Groundwater Transfer Review Summary Form

Transfer/PA # T- 14305

Application: T-14305

Applicant Name: K2A Properties LLC

Map

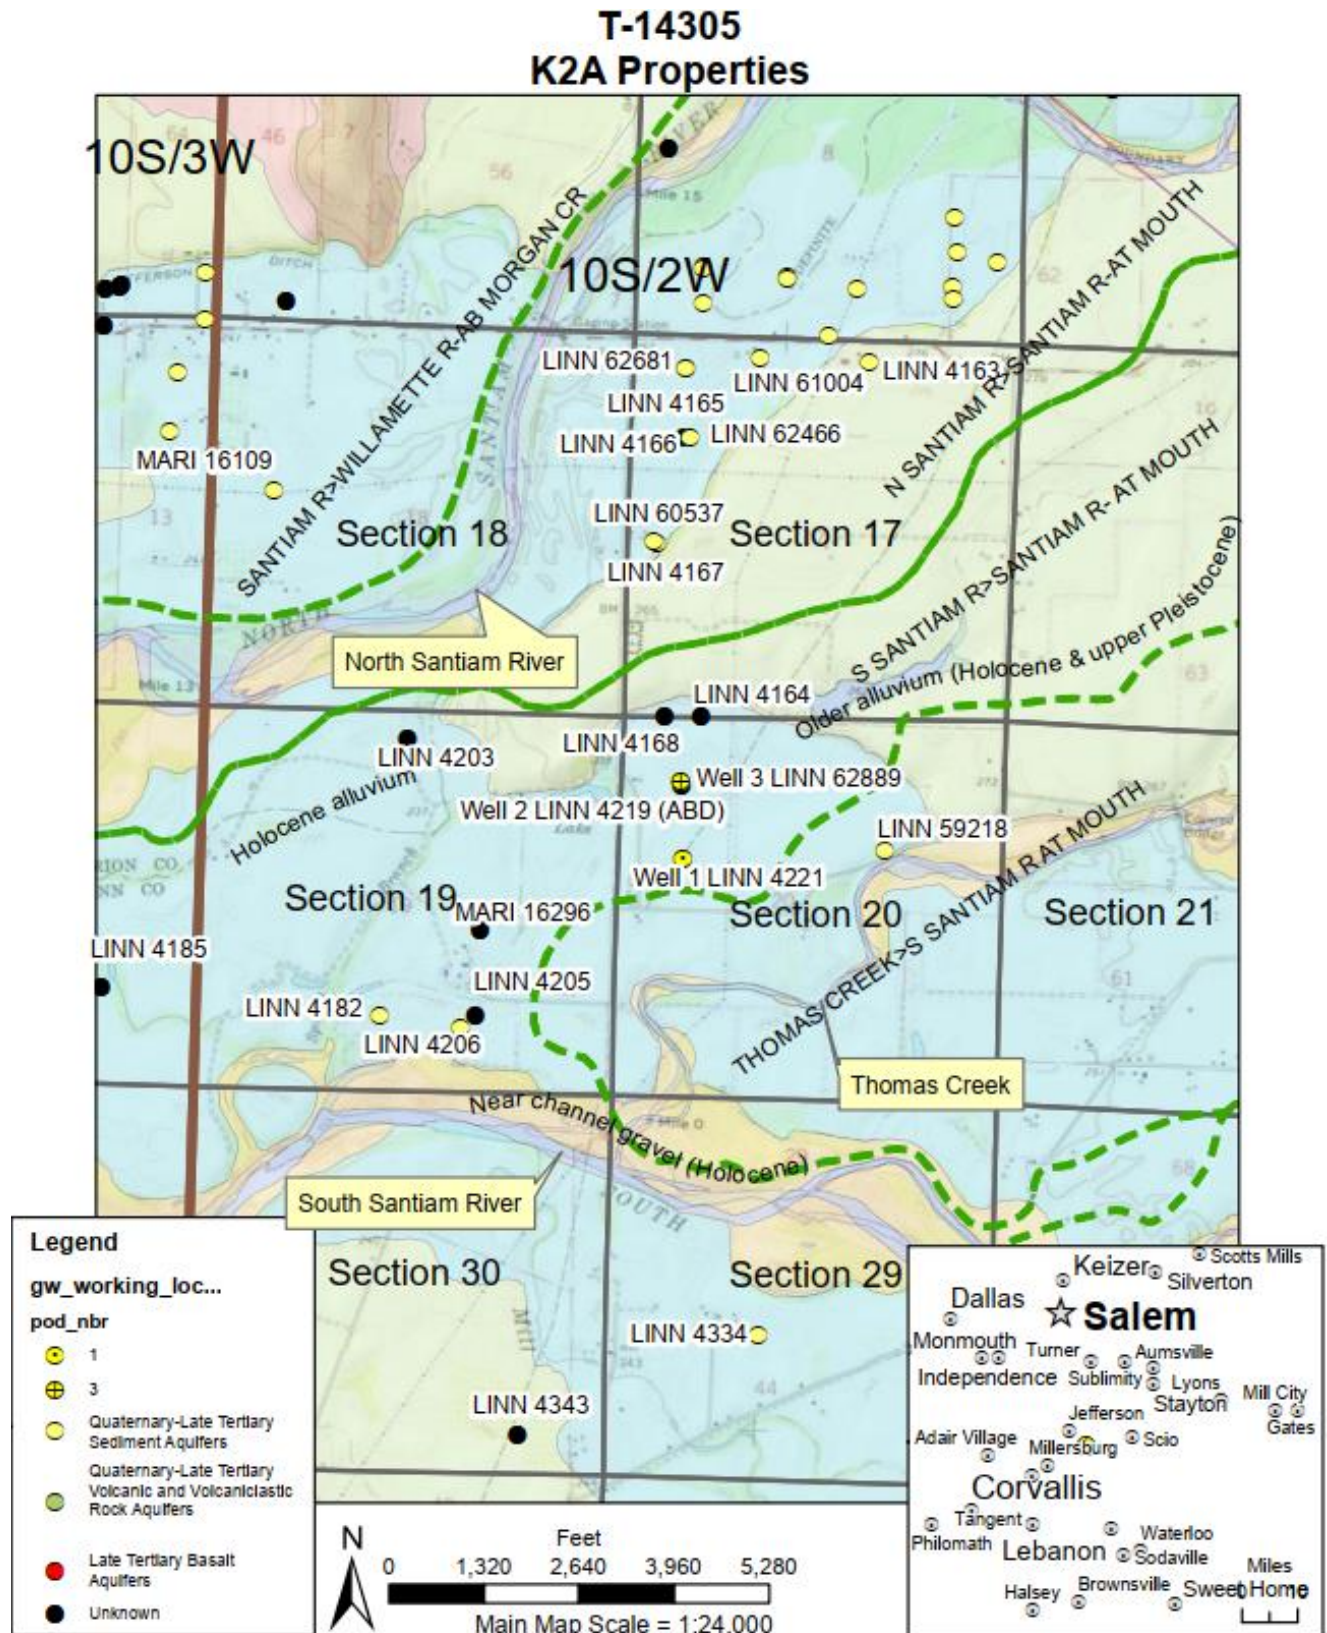
4. a) Will this proposed change, at its maximum allowed rate of use, likely result in an increase in interference with **another ground water right**?
☒ Yes ☐ No Comments: The closest groundwater user to the authorized POA Well 1 (LINN 4221) and the APOAs Well 2 (LINN 4219) and Well 3 (LINN 62889) is LINN 4168 authorized under Claim GR-1034 at an elevation of 243 ft amsl and located approximately 2,000 ft north of Well 1 (LINN 4221), 986 ft north of Well 2 (LINN 4219), and 940 ft north of Well 3 (LINN 62889).

☒ Yes ☐ No Comments: Thomas Creek is 1,767 ft from the authorized POA Well 1 (LINN 4221), 2,854 ft from APOA Well 2 (LINN 4219), and 2,890 ft from APOA Well 3 (LINN 62889); transfer to Wells 2 and 3 is anticipated to result in a decrease in interference with Thomas Creek. The North Santiam River is 4,427 ft from authorized Well 1 (LINN 4221), 3,681 ft from APOA Well 2 (LINN 4219), and 3,642 ft from APOA Well 3 (LINN 62889); transfer to Wells 2 and 3 is anticipated to increase interference with the North Santiam River. The South Santiam River is 4,255 ft from authorized POA Well 1 (LINN 4221), 5,168 ft from APOA Well 2 (LINN 4219), and 5,212 ft from APOA Well 3 (LINN 62889); transfer to Wells 2 and 3 is anticipated to decrease interference with the South Santiam River. Thomas Creek, the North Santiam River, and the South Santiam River are in different WABs, THOMAS CR > S SANTIAM R – AT MOUTH, N SANTIAM R>SANTIAM R-AT MOUTH, and S SANTIAM R > SANTIAM R - AT MOUTH, respectively.

Provide context for minimal/significant impact: The increased interference with the North Santiam River is anticipated to be minimal, as the decreased distance is minimal relative to the overall distance and interference is anticipated to propagate to all three surface water sources.
